**Our Case Number:** ABP-314597-22

**Re:** BusConnects Galway Cross-City Link Scheme.  
University Road to Dublin Road, Galway City.

Case reference: HA61.314597 University Road to Dublin Road, Galway City.

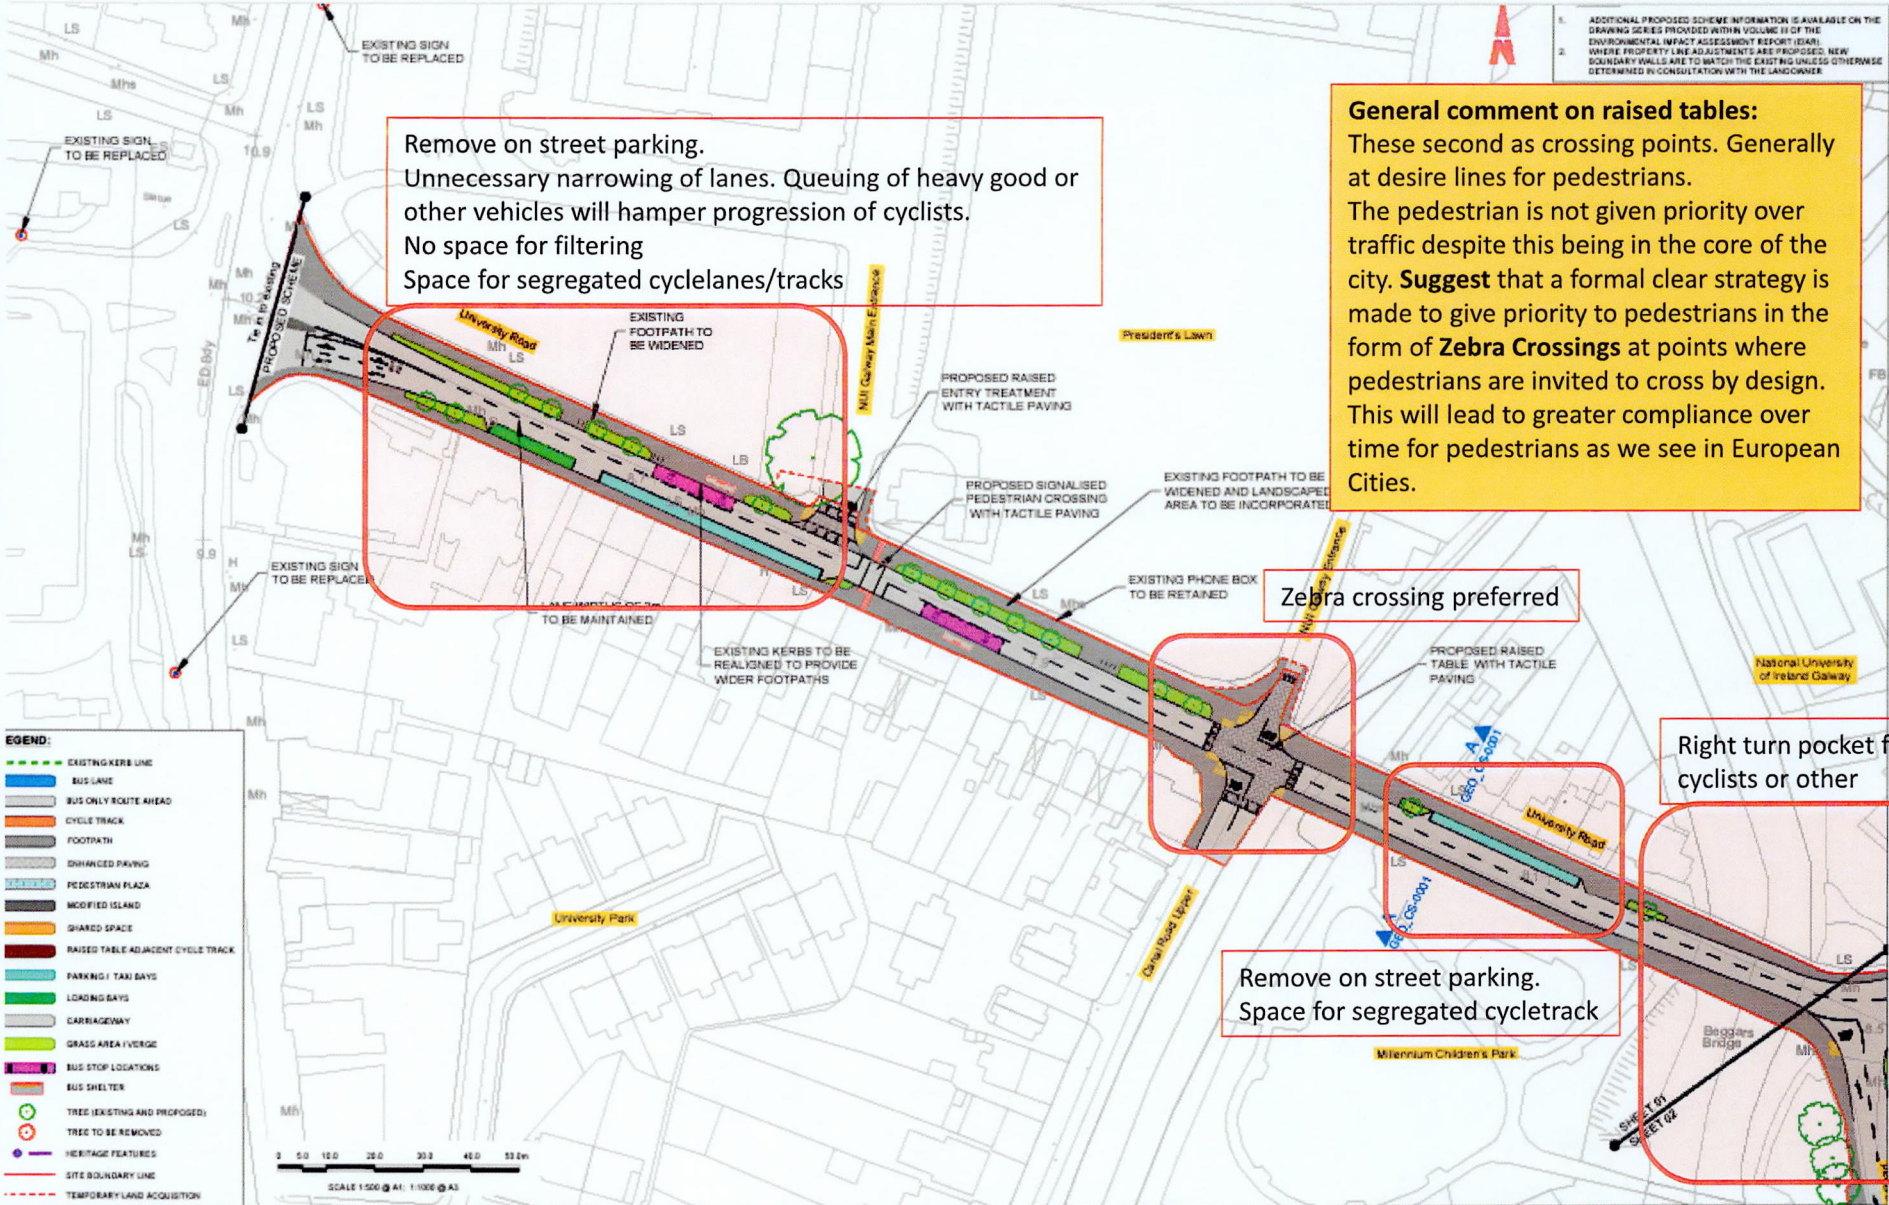
No bike parking shown

Remove on street parking.  
Unnecessary narrowing of lanes. Queuing of heavy good or other vehicles will hamper progression of cyclists.  
No space for filtering  
Space for segregated cyclelanes/tracks

**General comment on raised tables:**  
These second as crossing points. Generally at desire lines for pedestrians.  
The pedestrian is not given priority over traffic despite this being in the core of the city. **Suggest** that a formal clear strategy is made to give priority to pedestrians in the form of **Zebra Crossings** at points where pedestrians are invited to cross by design. This will lead to greater compliance over time for pedestrians as we see in European Cities.

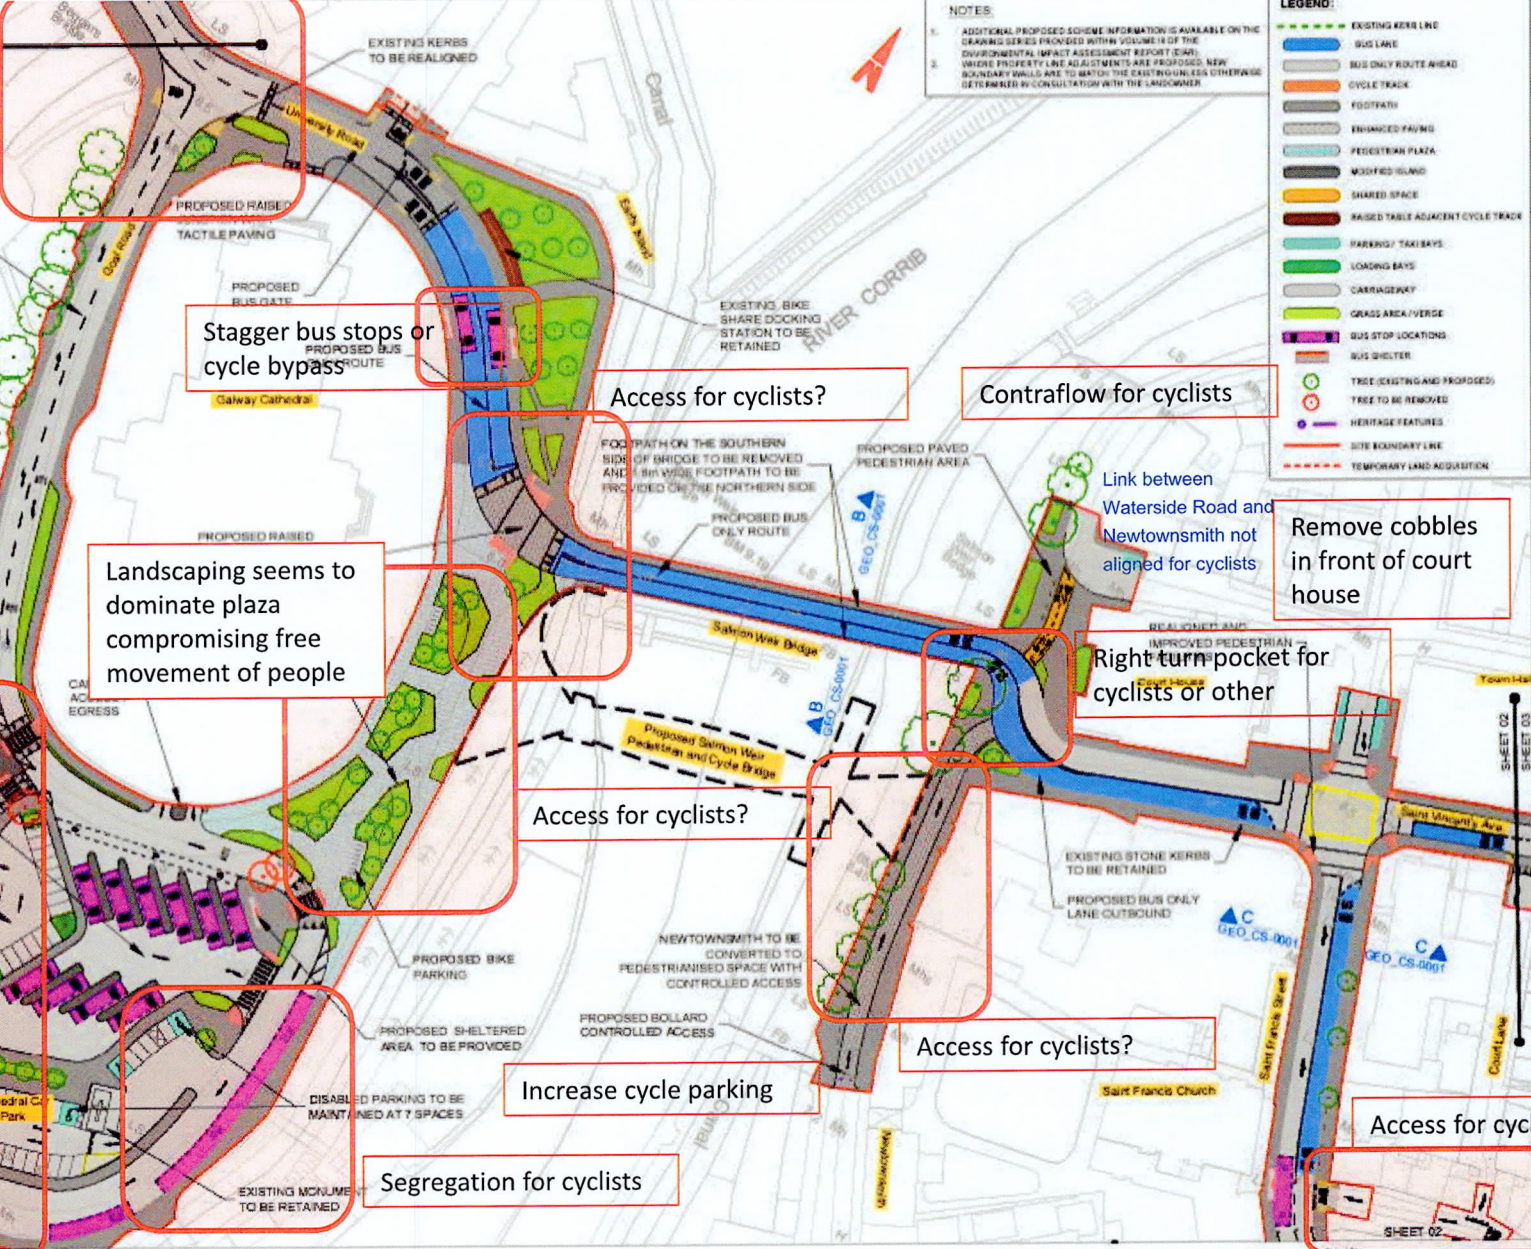
Remove on street parking.  
Space for segregated cycletrack

Remove cobbles in front of court house

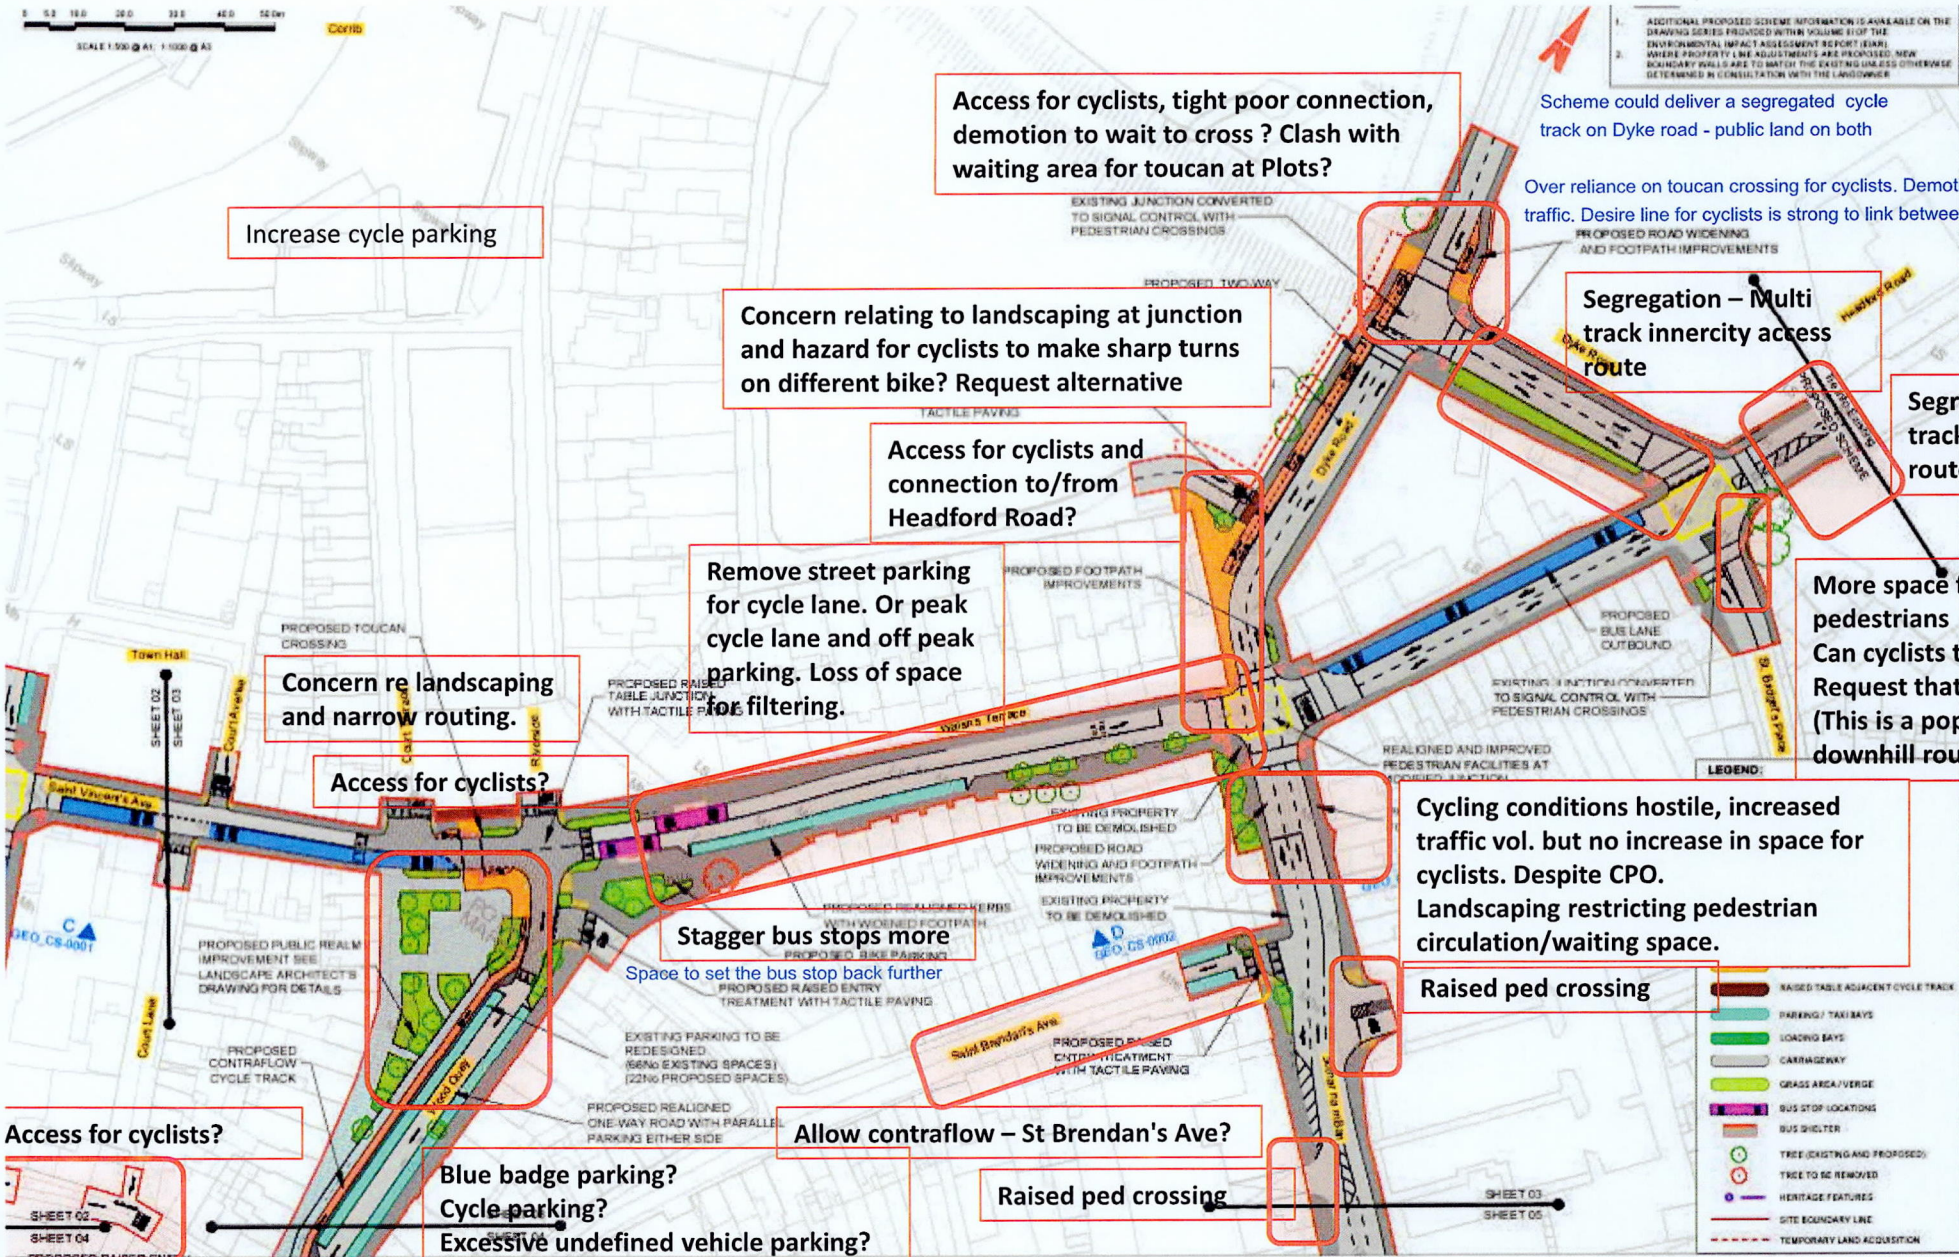
Segregation for cyclists

Access for cyclists?

Remove street parking for cycle lane. Or peak cycle lane and off peak parking. Loss of space for filtering.

SHEET 03  
SHEET 05

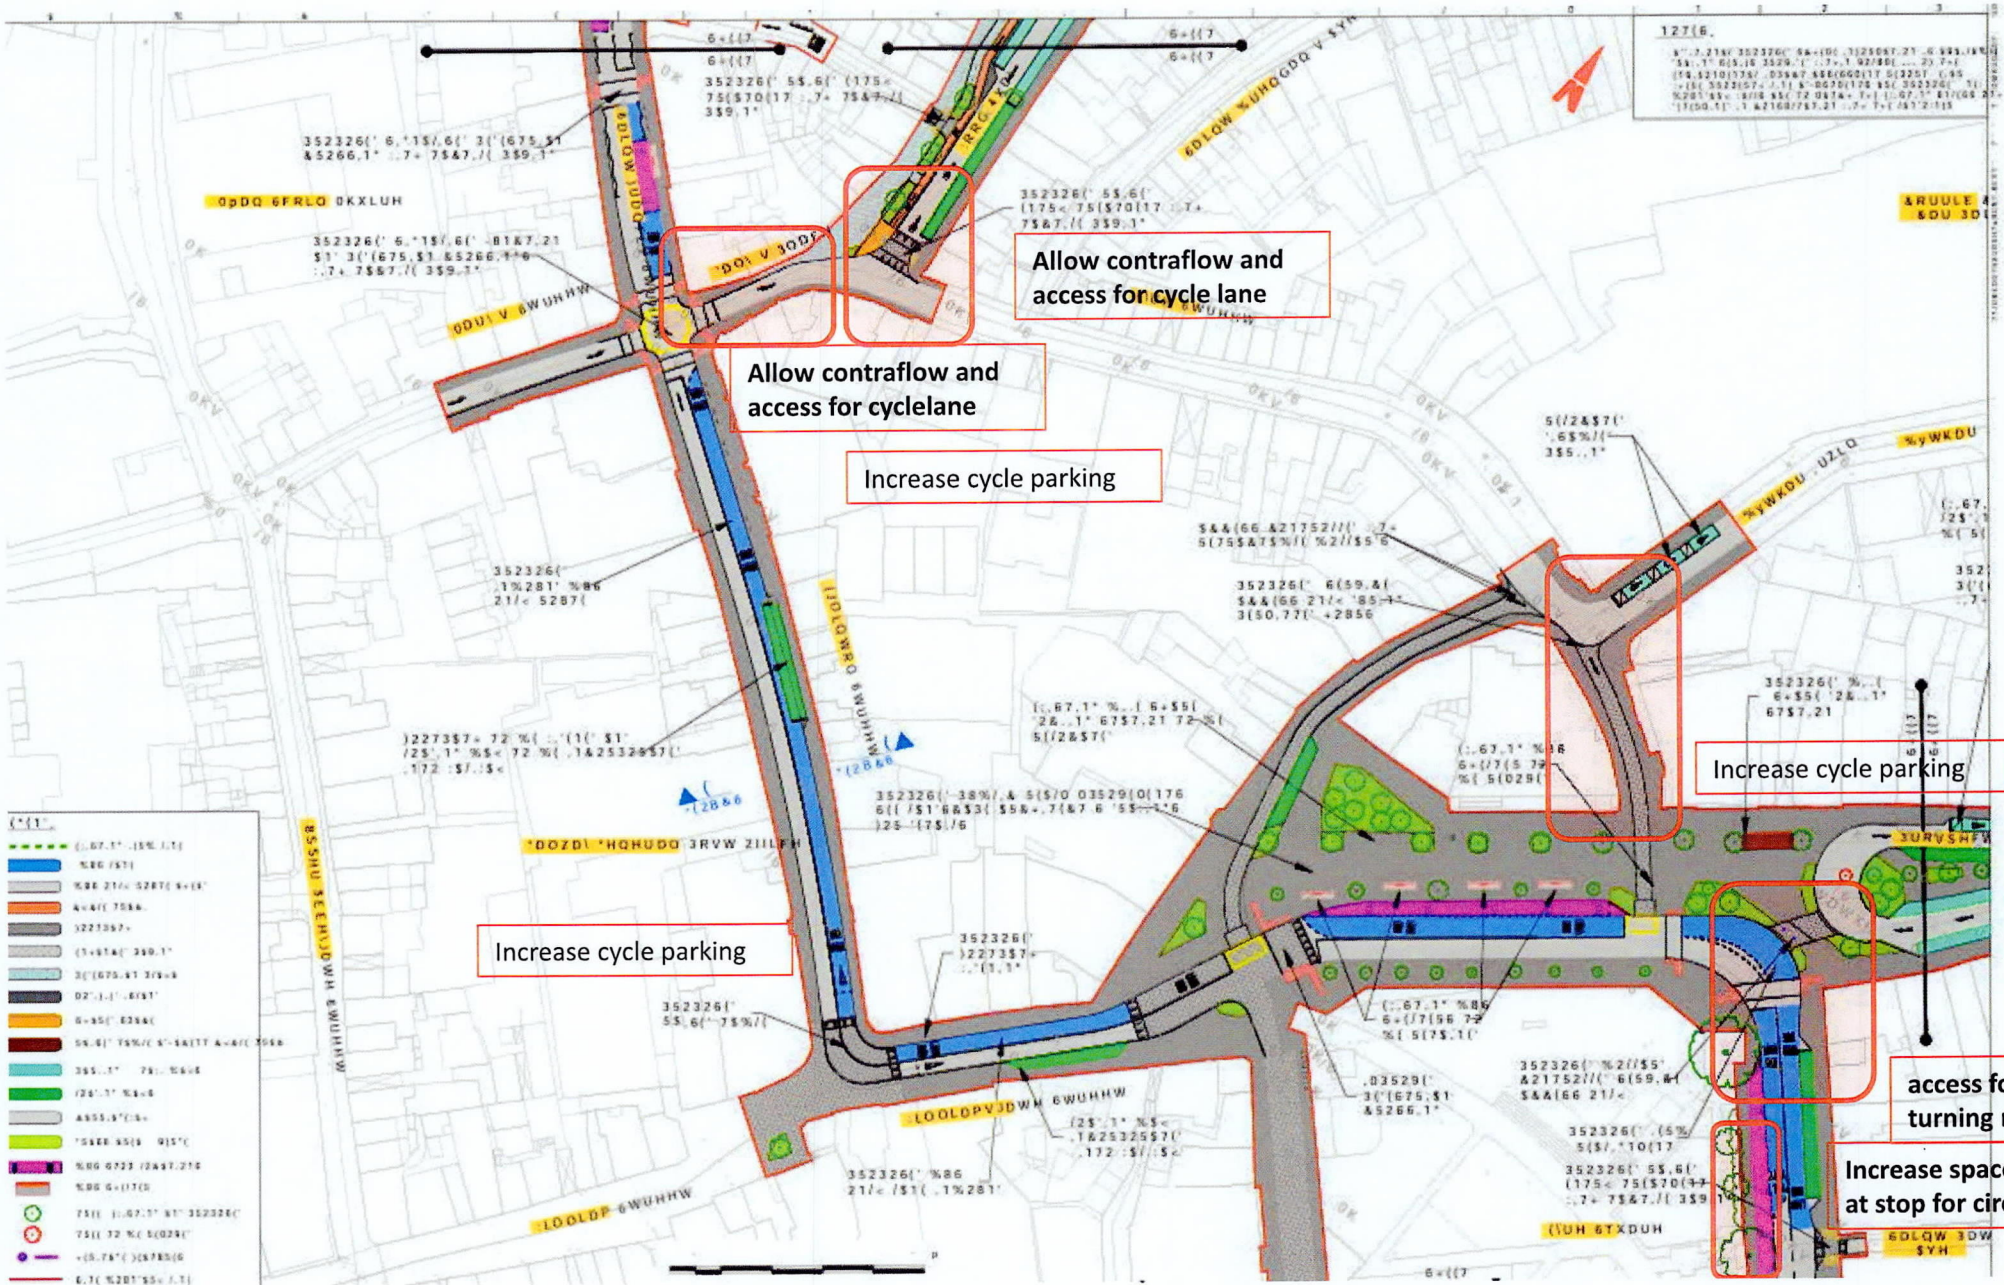
Raised ped crossing

**Allow contraflow and access for cycle lane**

**Increase cycle parking**
